Access Compliance Report Public Rights-of-Way (Curb Ramps)

Intersection ID: 27641 Main Street: BALLANTYNE_COUNTRY_CLUBrobs Street: YOUNG_POPLAR_PL Location: NE

ADA ID: 0B670A267713 Ramp Type: Perp Initial Pass/Fail: Fail Overall Compliance: No Severity Score: 26.25

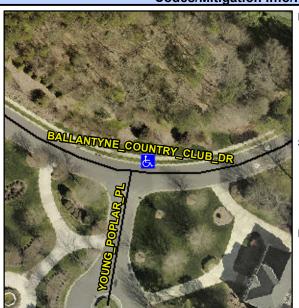
Possible Solutions:	Con
Remove & Replace Entire Ramp.	N/A
	Yes
	N/A
	N/A
	N/A
	N/A
Surveyor Notes:	N/A
N/A	N/A
	N/A
	N/A
	N/A
PROW/ADA:	N/A
Not Found, R304.2.2	N/A
	N/A
	N/A
	N/A

Comp	liance Description	Data	Comp	liance Description	Data
N/A	Ramp Length (in)	48.0	No	Ramp Slope (%)	13.2
Yes	Ramp Width (in)	48.0	Yes	Ramp XSlope (%)	3.6
N/A	Flare Type LT	N/A	N/A	Flare Type RT	N/A
N/A	Flare Slope LT (%)	N/A	N/A	Flare Slope RT (%)	N/A
N/A	Flare Traversable LT?	N/A	N/A	Flare Traversable RT?	N/A
N/A	Landing Length (in)	N/A	N/A	DWS Provided?	N/A
N/A	Landing Width (in)	N/A	N/A	DWS Contrast?	N/A
N/A	Landing Slope (%)	N/A	N/A	DWS Length (in)	N/A
N/A	Landing X Slope (%)	N/A	N/A	DWS Full Width?	N/A
N/A	Landing Curb? (Y/N)	N/A	N/A	DWS Offset (in)	N/A
N/A	Shared Landing?	N/A			
N/A	Gutter Ponding?	N/A	N/A	Gutter Slope (%)	N/A
N/A	Gutter Lip Ht (in)	N/A	N/A	Gutter X Slope (%)	N/A
N/A	Painted X Walk1?	No	N/A	Painted X Walk2?	N/A
	X Walk 1 Direction	To S		X Walk 2 Direction	N/A
N/A	X Walk 1 Width (in)	N/A	N/A	X Walk 2 Width (in)	N/A
	X Walk 1 Slope (%)	5.9		X Walk 2 Slope (%)	N/A
	X Walk 1 X Slope (%)	3.7		X Walk 2 X Slope (%)	N/A
